La Vergne Planning Commission
August 26, 2025 at 6:00 PM

Item #: 3. Site Plan – Smoke Club 13 – New Building of 2,759 Square Feet on 0.42 Acres. Requested by Dean Design Group. Property located at 5234 Murfreesboro Road (Tax Map 15M, Group C, Parcel 6). C-2 (Highway Service) Zoning District. Property owned by Smoke Club 13, LLC.

Smoke Club 13

Initial Sediment Control Plan
Demo & Erosion Control Plan

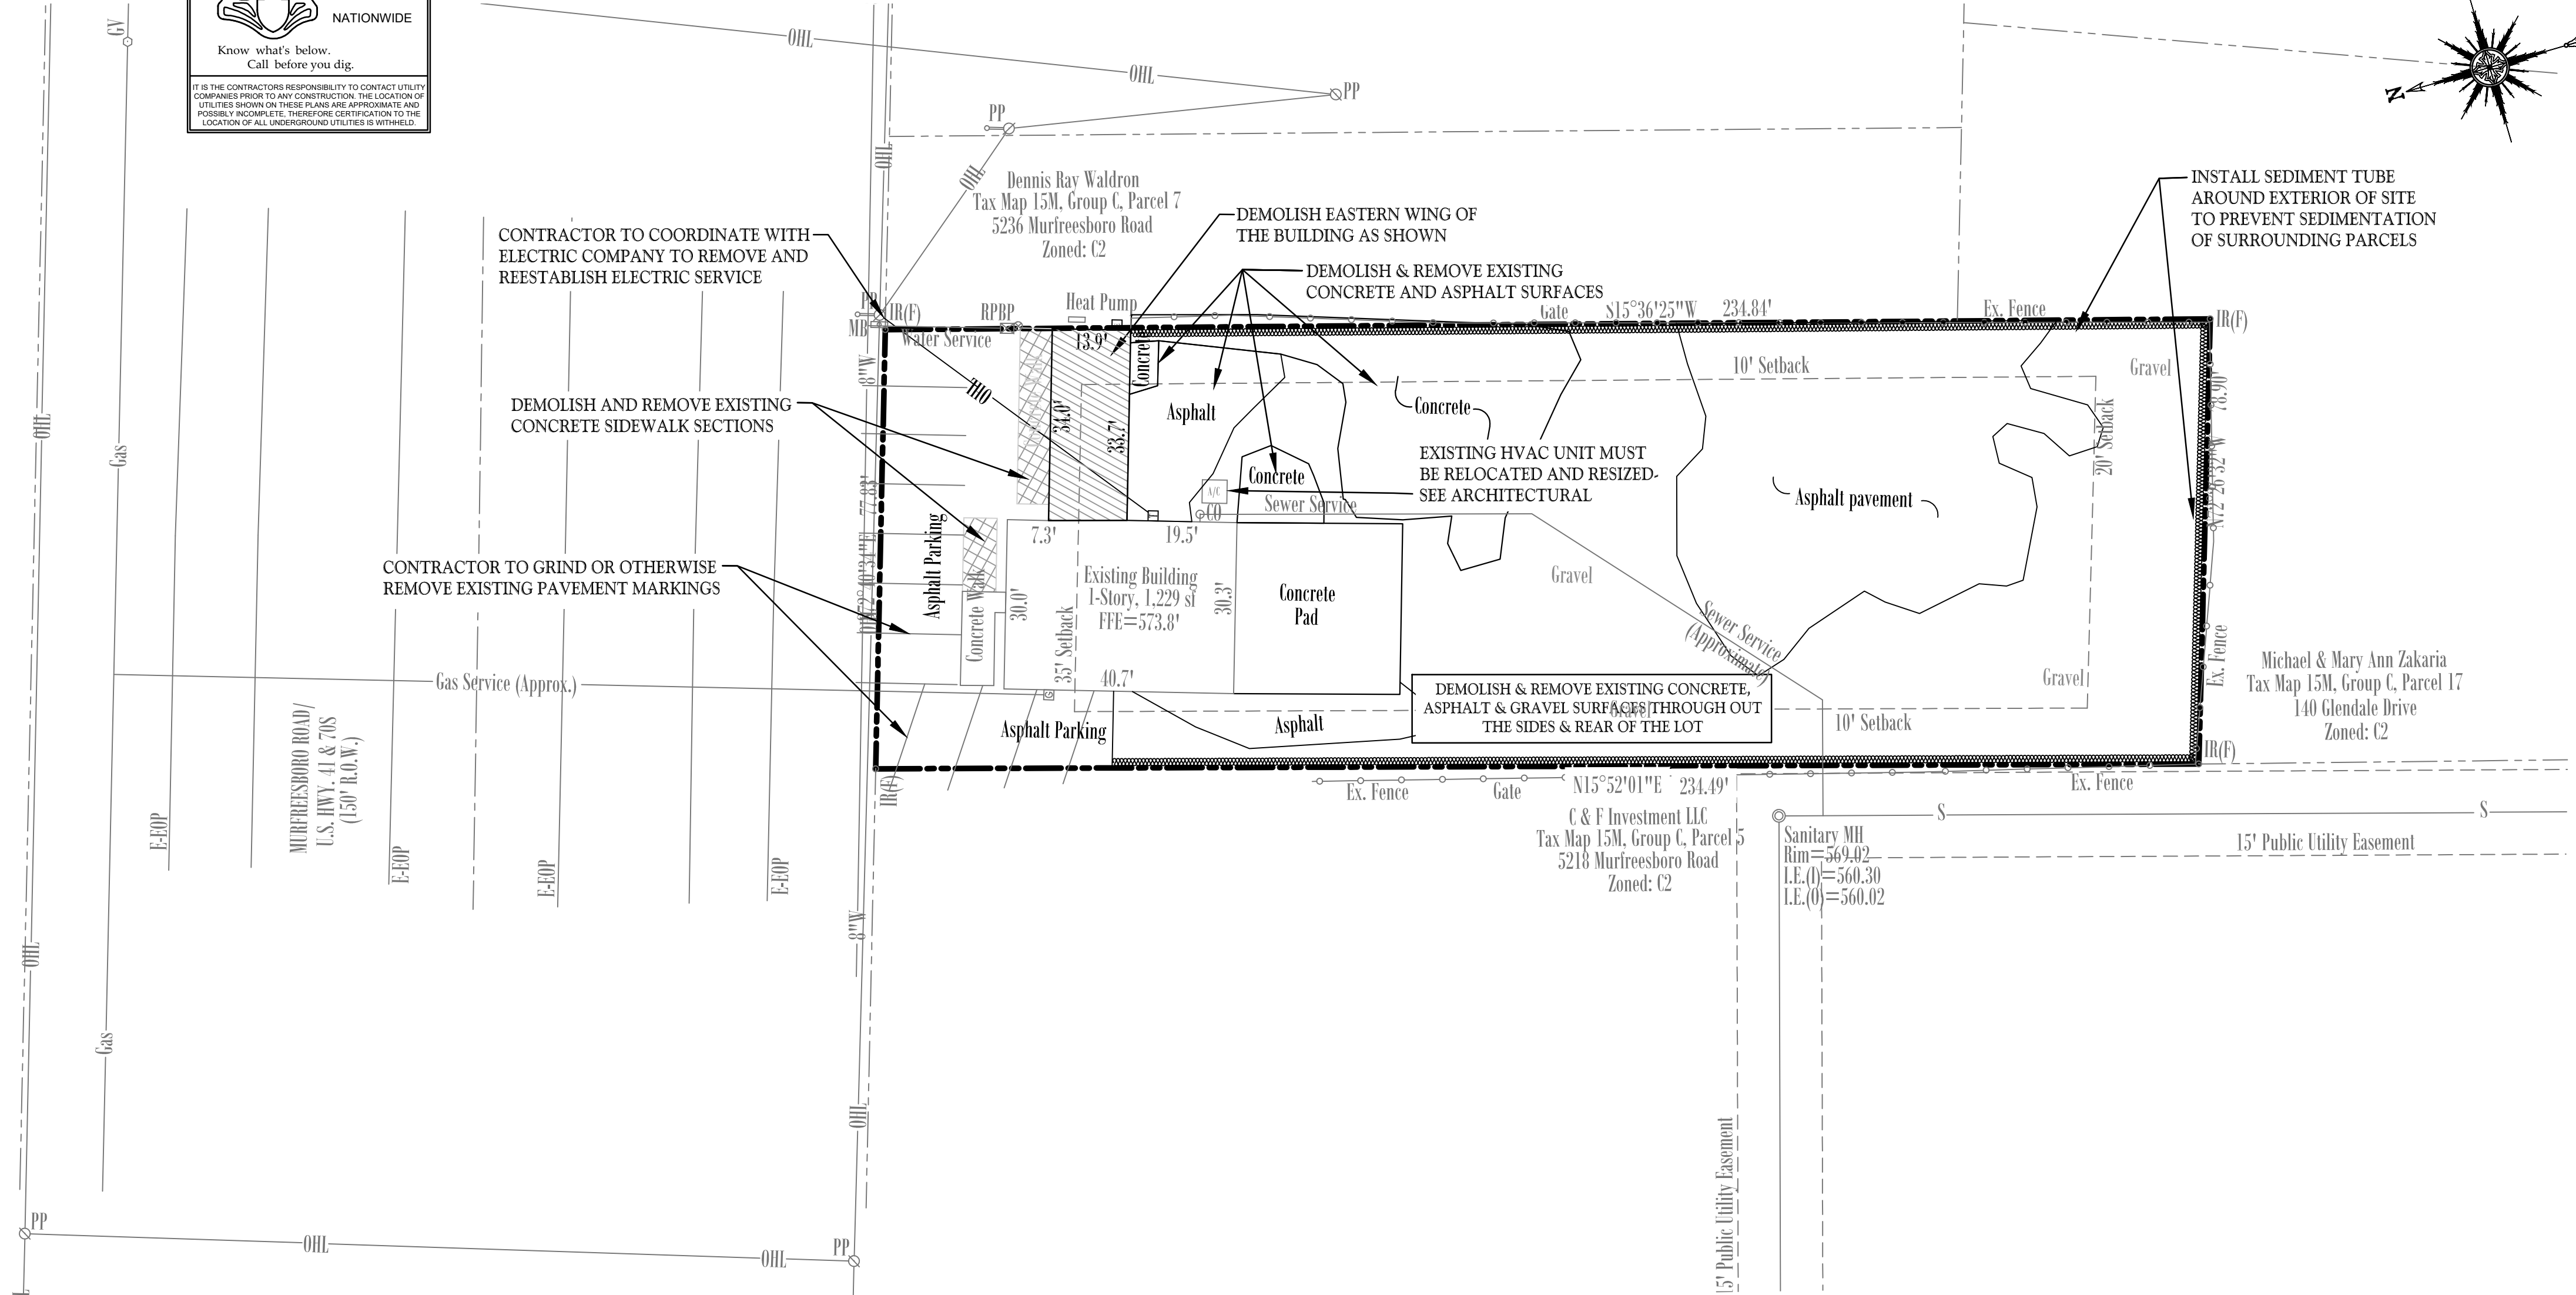
1. Show stakes on both sides of wattle tubes (eels) on the detail.
2. Submit a filled-out Longterm Maintenance Agreement (LTMA) which includes a Longterm Maintenance Plan (LTMP). Get with Alexandra Thompson (615-287-8658) for assistance.
(<https://www.laveragnetn.gov/DocumentCenter/View/3971/Long-Term-Maintenance-Agreements---La-Vergne>)

Layout Plan

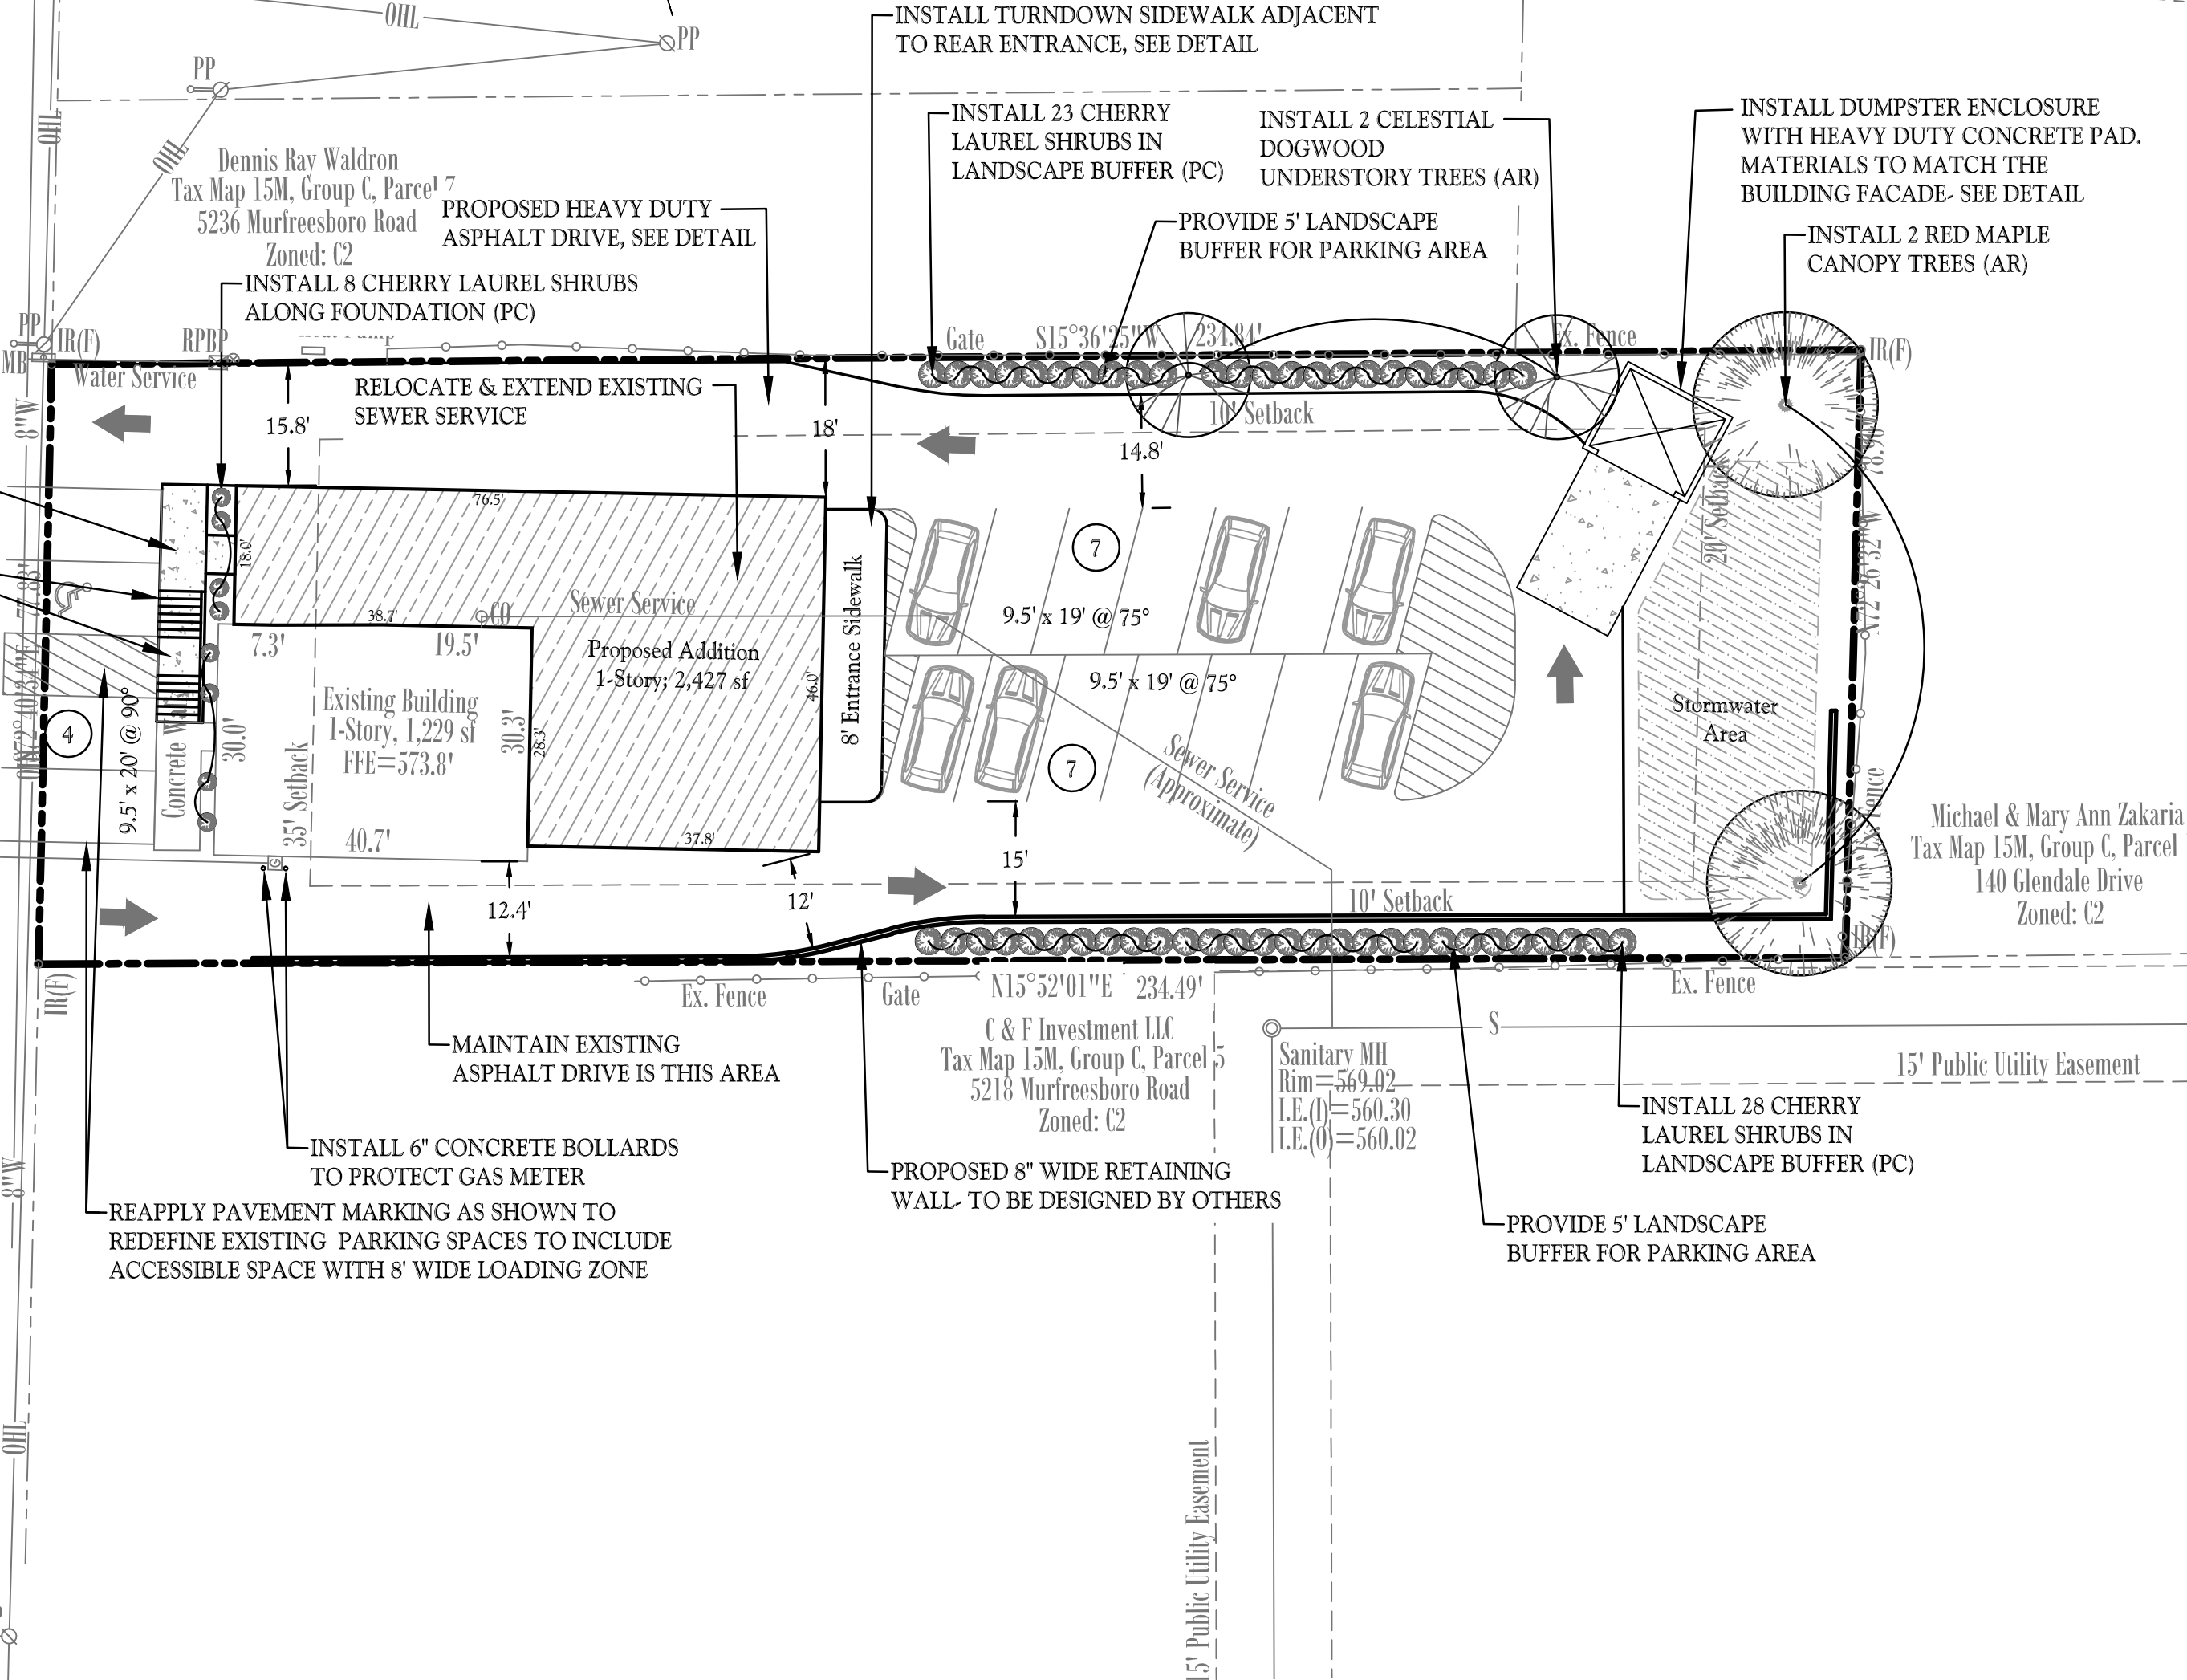
1. There are two (2) businesses shown on the plans after the public conversation last month that these 2 bus. will not be allowed;
2. Two businesses are not allowed;
3. Front parking spaces must be removed;
4. All utilities must be underground;
5. Exact location of new 6' sidewalk along Murf. Rd. needs to be determined.

SITE PLAN

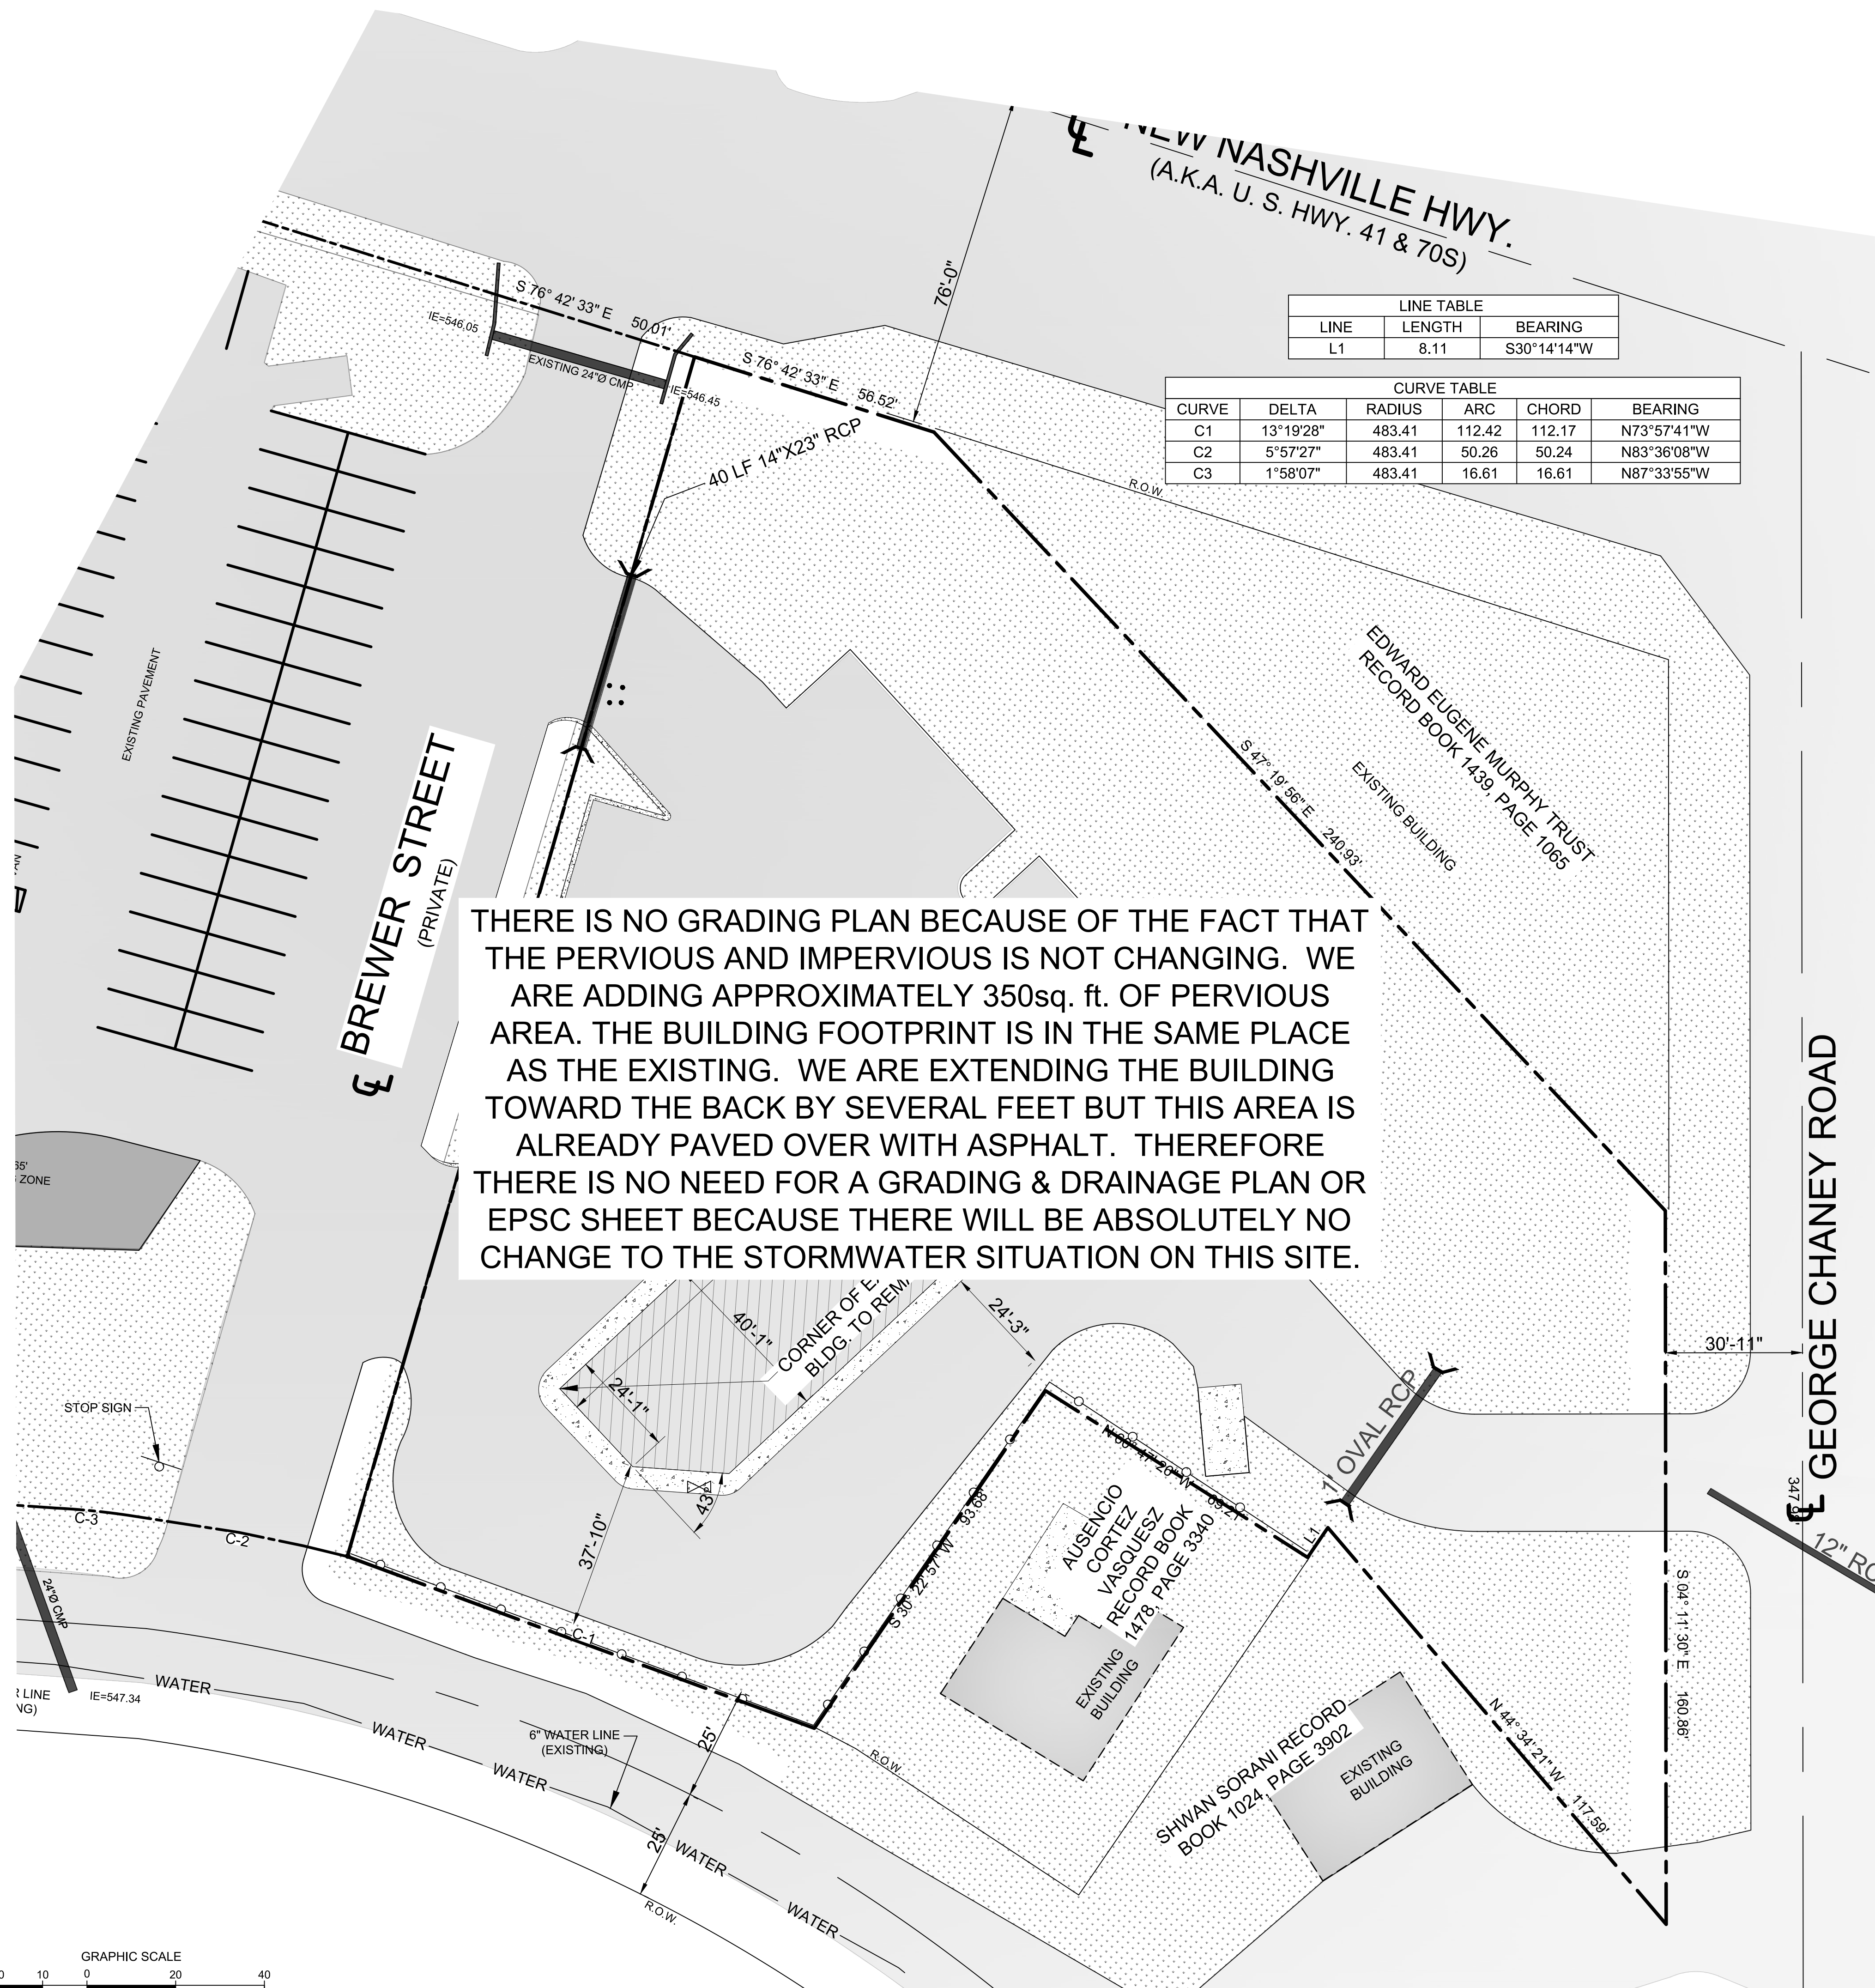
1. (Sheet C-2.1b) Provide a grading and drainage plan showing how site run-off will be handled for the modified structure. Staff does not concur with engineer's statement on the second Sheet C-2.1 that no grading plan is required. The architectural plans show doorways exiting from the proposed portion of the building which will require existing and proposed elevations to confirm IBC and ADA access requirements are met. The grading plan should show, at a minimum:

7. (Sheet C-7.0) The silt fencing shown on the intermediate EPSC plan should be shown on the Initial EPSC Plan (C-7.0).
8. (Sheet C-2.1) It is strongly preferred by staff to connect the proposed walk along Brewer Street with the proposed sidewalk along Murfreesboro Road.
